Subject: Oak Cliff Estates

Gen Comments for Sketch Plat

PROJECT: OAK CLIFF ESTATES

- Oak Cliff Estates - Sketch Plat

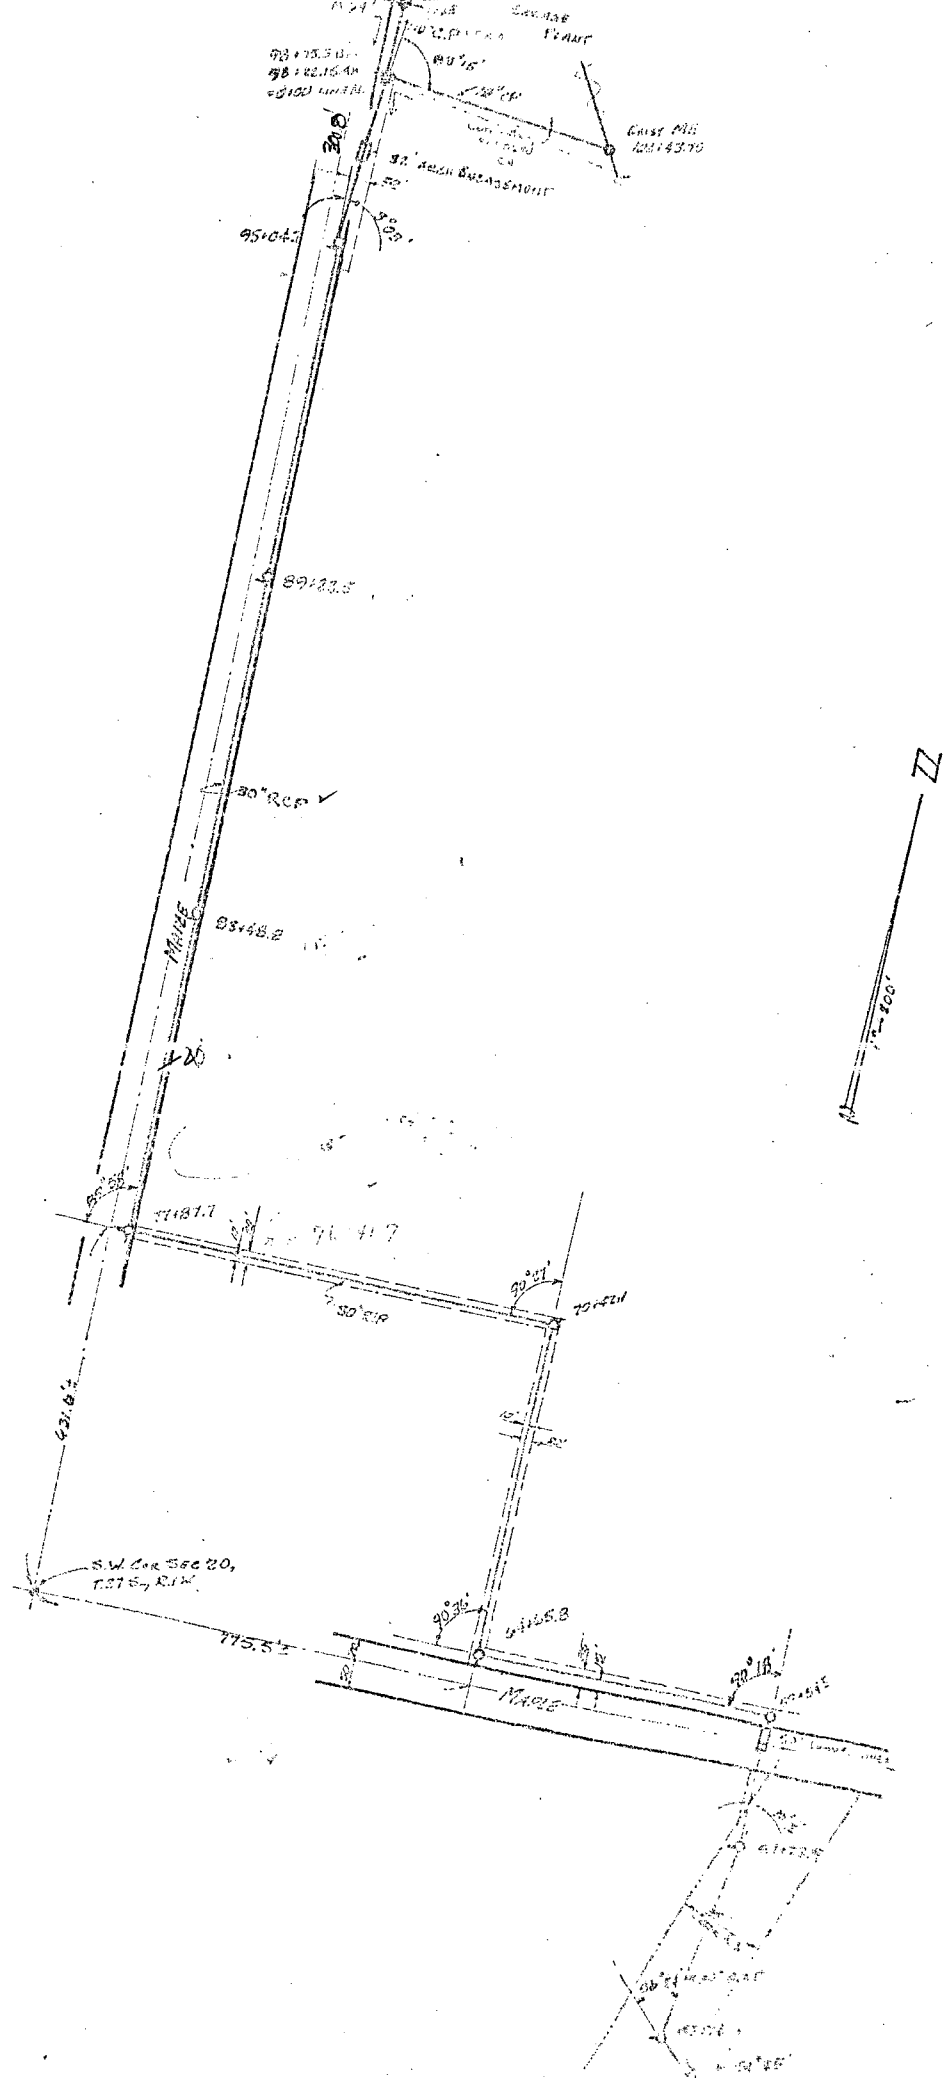
Subject - Drainage from Oak Cliff Estates (proposed)
to Maple Gardens

On Maple Road (based upon info submitted by county 1-16-80)

Elevations: Roadway 1321.47
@ 7x3 box 1316.42
5.05' head at box

Based upon the contours provided for Oak Cliff Estates flow will occur over the roadway at the corner of Maple & Maple before topping the 7x3 structure in Maple.

Elevations: South of 7x3 structure 1320
~ 1317
3'

Head at structure before crossing roadway south 1320
1316.4
3.6'

Using Chart 1 - Hydr. Charts for the Selection of Highway Culverts

$$H_w/D = \frac{3.6}{3} = 1.2 \quad 30^\circ - 75^\circ \text{ wing walls}$$

$$Q/B = 19 \therefore Q = 19B = 19(7) = \underline{133 \text{ cfs}} \quad \text{before flowing over road}$$

Based upon calculation by Max 9-19-77

$$DA = 105 \text{ A. } t_c = 20 \text{ min } L_{100} = 6.2 \quad C = 0.5 \text{ developed}$$

Rational Formula

$$Q = ciA = 0.5 (6.2) 105 = 325 \text{ cfs} \quad \text{developed}$$

$$0.2 (6.2) 105 = \underline{130 \text{ cfs}} \quad \text{undeveloped}$$

$$\text{if } 0.3 (6.2) 105 = 242 \text{ cfs}$$
